LEGAL NOTICE EXETER PLANNING BOARD AGENDA

Date: March 5, 2020
To: Planning Board
From: Dave Sharples, Town Planner
Re: People's United Bank
1 Center Street
PB Case #20-3

**Re: Peoples United Bank Parking Lot Redevelopment Site Plan Review
Design Review Engineering Services
Exeter, New Hampshire**

LOCATION PLAN
EXETER, NH
NOT TO SCALE

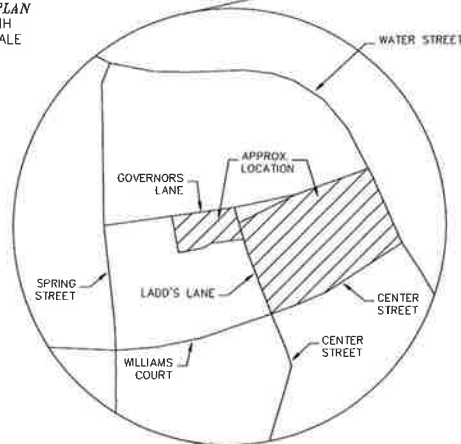
Cover Sheet

5. A wetland scientist is listed, but no wetlands exist onsite and no wetland delineation is listed on the existing conditions plan. This should be removed as appropriate.
6. The orientation of the location plan is different from the vicinity sketch. A second north arrow should be added.

7. The location plan calls out Ladd's Lane where the vicinity sketch calls out Governors Lane. Coordination is needed.

EXISTING CONDITIONS PLAN
LAND OF
CHITTENDEN BANK, C/O PEOPLE'S UNITED BANK
WATER STREET, CENTER STREET, LADD'S LANE, &
1 CENTER STREET
EXETER, N.H.
TAX MAP 72, LOTS 205 & 216

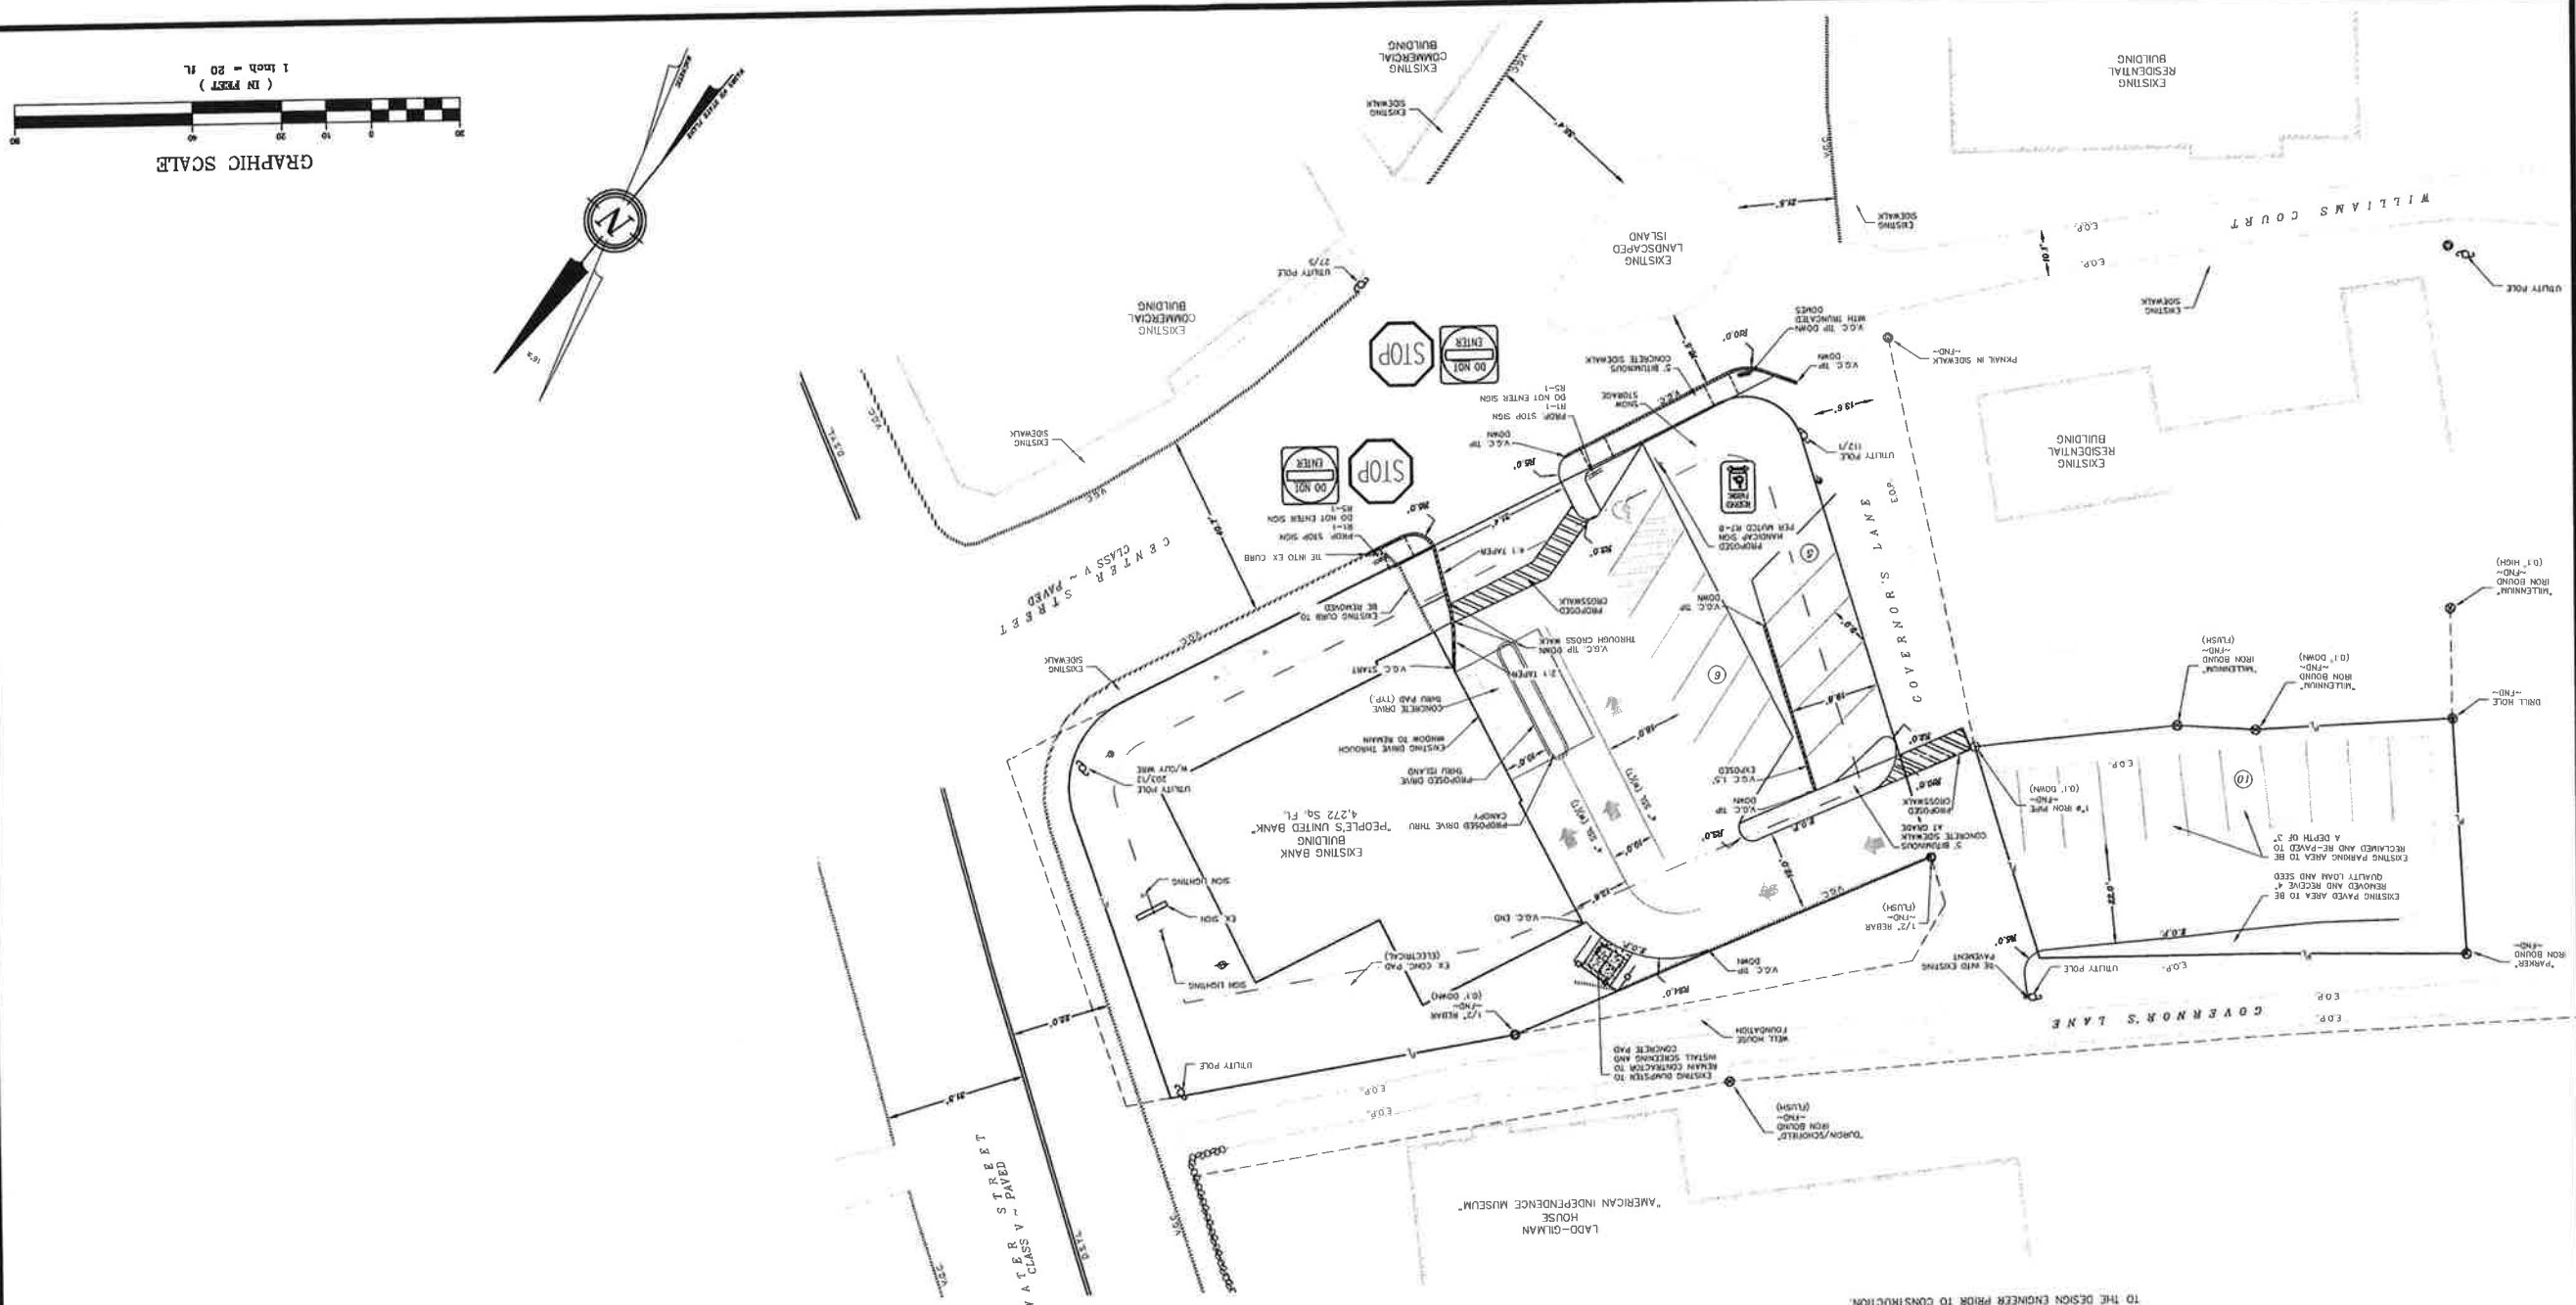
Existing Conditions Plan

8. **Legend:** There is a dashed line around part of the property, also shown on both sides of Governors Lane to the west, on Sheets 3 and 4. This line is not labeled anywhere, and should be added to the Legend.
9. **Utilities:** All utilities on the parcels should be shown.
10. **Trees:** There is an existing tree to the southwest of the 32" stump near the Well House Foundation. This should be added to the plan.

SITE PLAN
LAND OF
CHITTENDEN BANK, C/O PEOPLE'S UNITED BANK
WATER STREET, CENTER STREET, LADD'S LANE, &
CENTER STREET
TAX MAP 72, 207/5 205 & 216

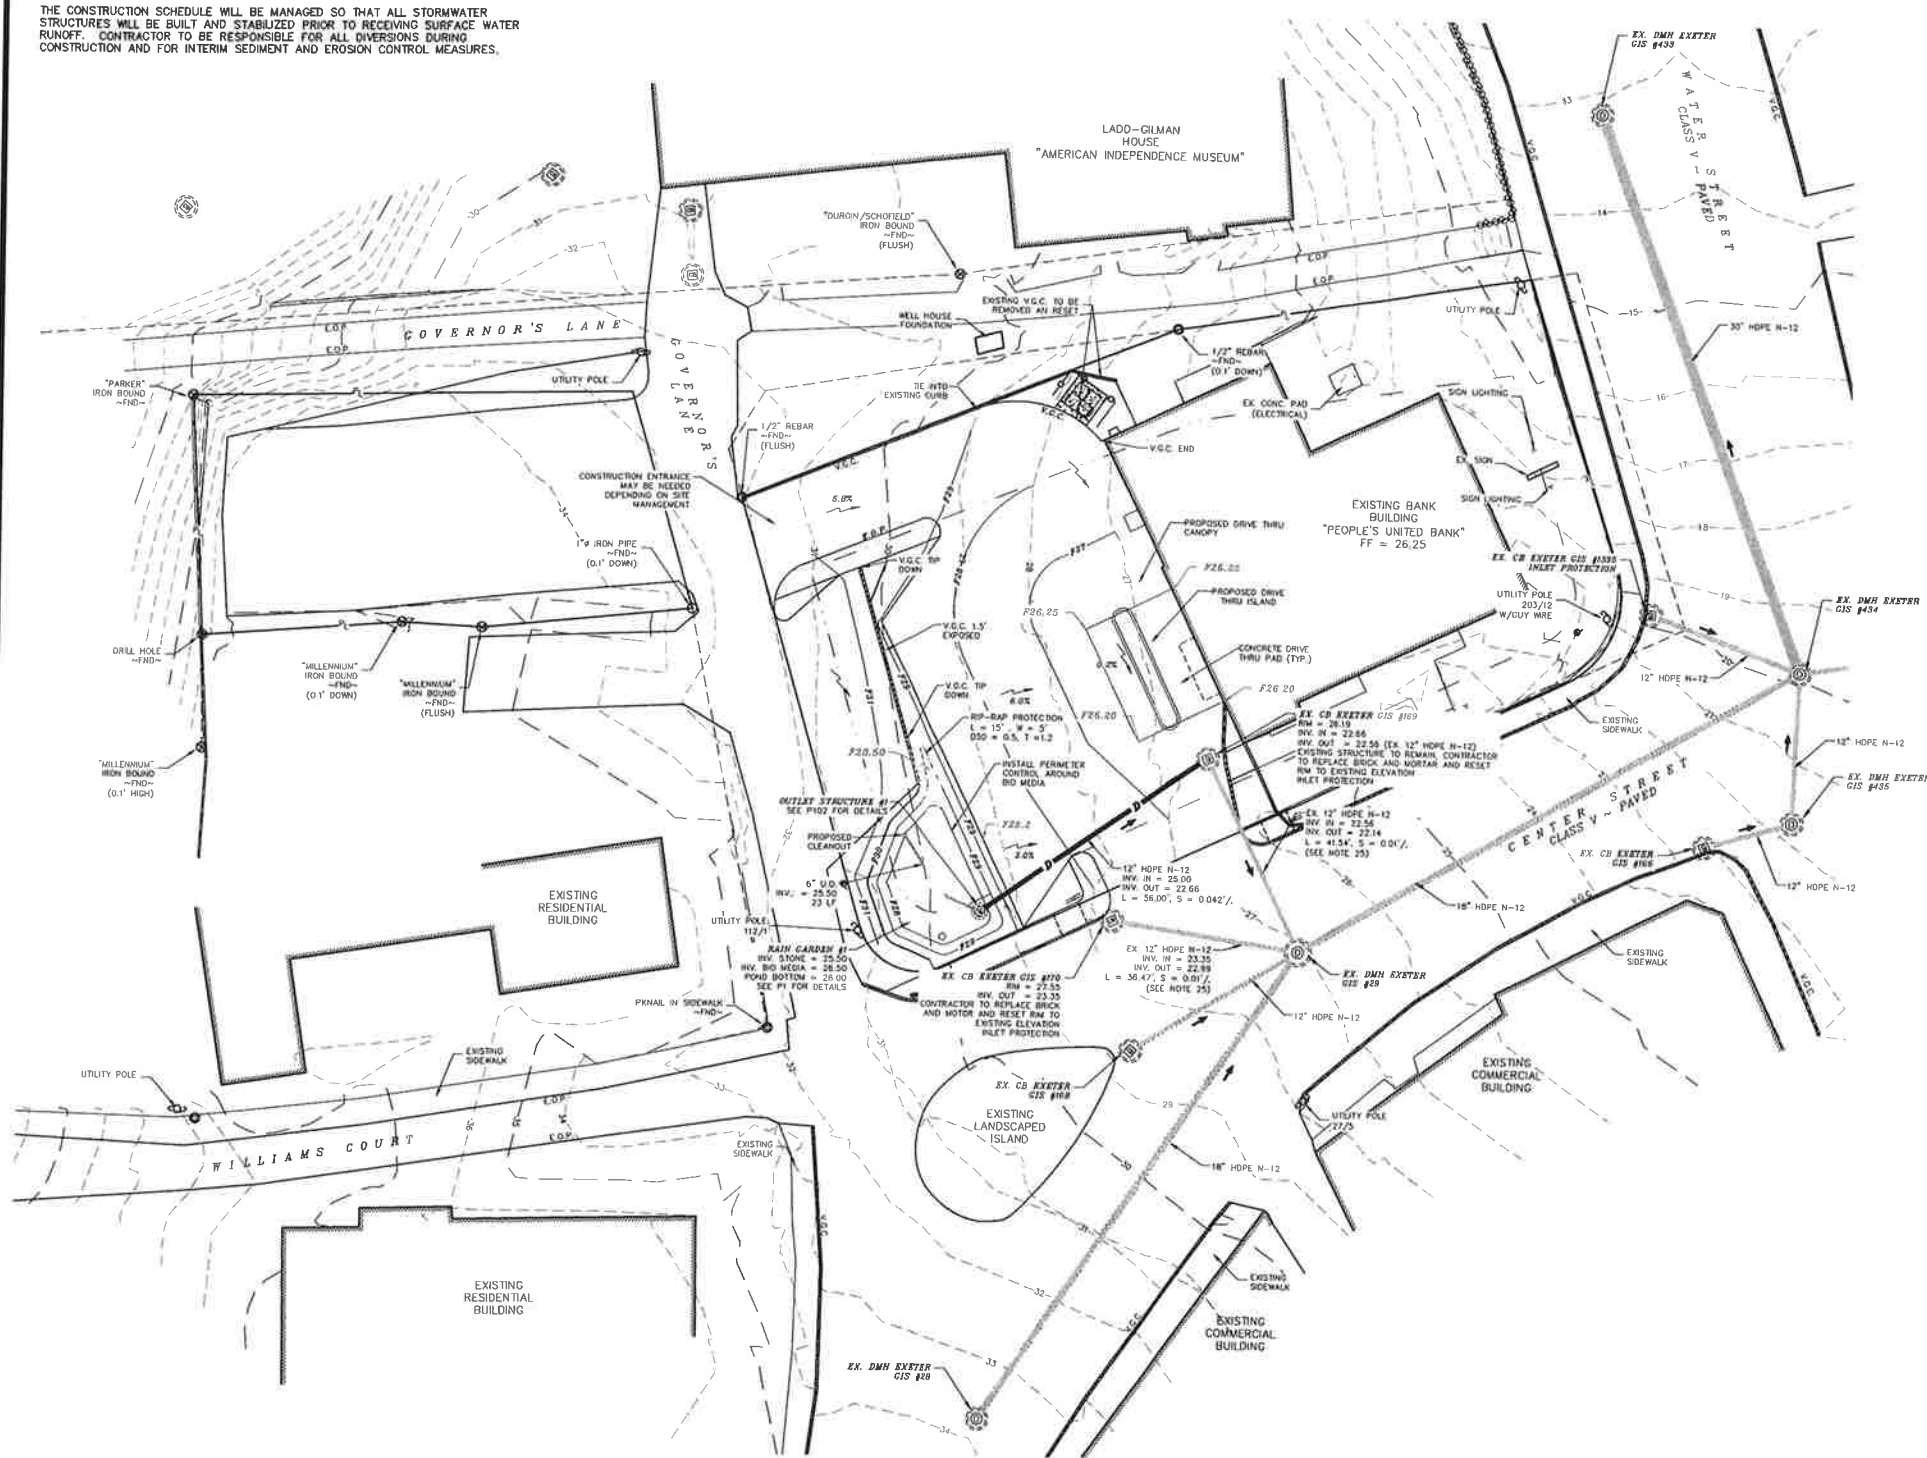
Site Plan

16. **Building Access:** There is a side door which opens out into the parking lot. This is shown on the Existing Conditions Plan by noting the concrete pad outside the door, but it is not shown on the Site Plan. Since this door will open into the vehicle queue for the drive-up window, please confirm the purpose and use of this door and how conflicts between the door and window queue will be handled. Is the door solid or equipped with a window?

17. **ADA Compliance:** Truncated domes are required at all sidewalk tip-downs within the ROW.
18. **Tree:** The existing tree noted in Comment 10 above has branches that extend to the EOP. Although the tree is not on this lot, a note should be added to protect the tree during construction.

19. **Underground Utilities:** Note 21 refers to underground telephone, electric, etc. If any new lines are proposed, these should be shown on the plans.

20. Impervious Area: Since two lots are part of this submission, Note 25 should be revised to list criteria for both Lot 205 and 216.

GRADING, EROSION & SEDIMENT CONTROL PLAN
 LAND OF
 CHITTENDEN BANK C/O PEOPLE'S UNITED BANK
 WATER STREET, CENTER STREET, LADD'S LANE, &
 CENTER STREET
 CENTER, N.H.
 TAX MAP 72, LOTS 205 & 216

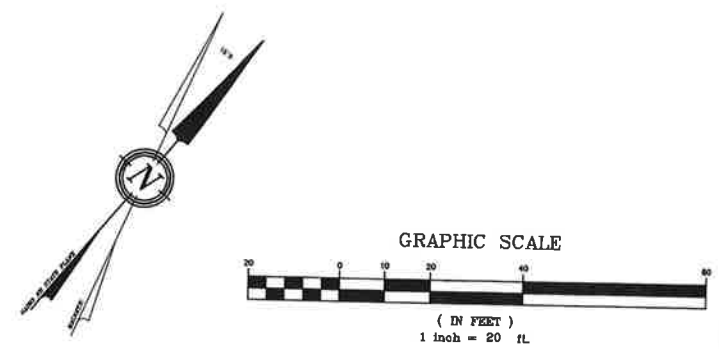
Grading, Erosion and Sediment Control Plan

22. Grading: Section 9.13.7.4 sets a max grade of 5%. Since this is an existing parking lot, we acknowledge challenging limitations in grading, however, the grades are as steep as 10%, and the finished floor of the bank is only 0.06 feet above the grade outside. In addition, the flood elevation of the rain garden is almost 3 feet higher than the building's finished floor, bringing into question the possibility of interior flooding in the event of overtopping.

23. Utilities: It is assumed from the structures shown on the Existing Conditions Plan that the water and sewer services are located on the Water Street side of the building. These should be shown on this plan as well.
